MEMORANDUM

San Joaquin River Crossing Design Refinement – Merced to Fresno Section

DATE: December 9, 2011

Additional Design Detail of the San Joaquin River Crossing

EXAMPLE PLAN AND ELEVATION
RIVER CROSSING

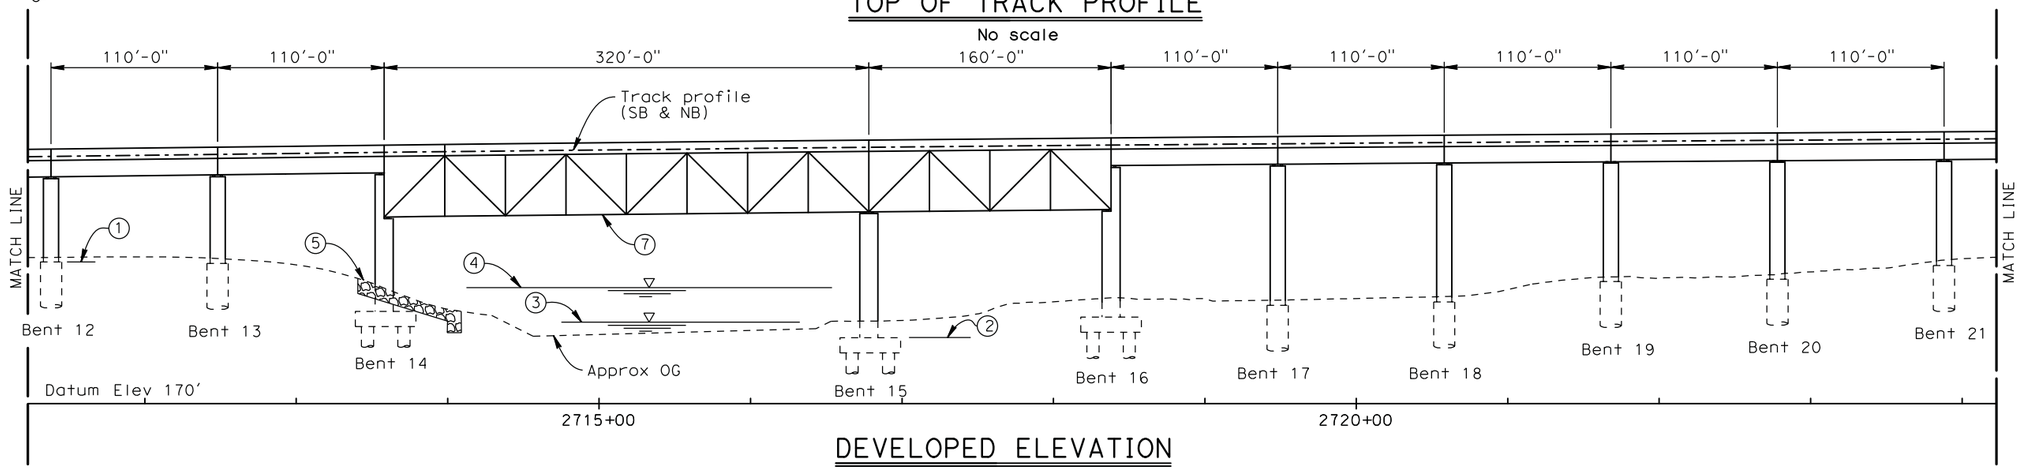
The design detail described below replaces the San Joaquin River crossing text found on pp. 2-16 thru 2-21, 2-25, 2-27 thru 2-30, and 2-32 thru 2-33 of the BA. Appendix A of this memorandum also provides the plan, elevation, and pier detail of the proposed San Joaquin River HST crossing, and Appendix B provides the 15% Design Set for the crossing.

Currently, the UPRR railway and the Caltrans SR 99 bridge structures downstream from the future crossing have piers in the San Joaquin River corridor that are spaced approximately 160 feet apart. The design refinement being proposed shows a configuration of the HST crossing that uses a combination of the typical precast segmental construction at each approach to the crossing and then spans the main low flow channel with a 160 to 320-foot steel truss superstructure to minimize the need to enter the wetted perimeter of the low-flow river channel.

1. CIDH Pile cut-off elevation.
2. Approx top of footing, min 1'-0" below calculated scour.
3. Approx water survace, Low Flow, Elev = 226.0'±.
4. Approx water surface - Base Flood = Q_{100}, Elev = 245.0'±.
5. Approx Limits of Rock Slope Protection for bank erosion and scour protection.
6. Approximate limit of CA State Floodway and FEMA-AE Zone.
7. Approximate elevation of low structure, Elev = 300.0'±.
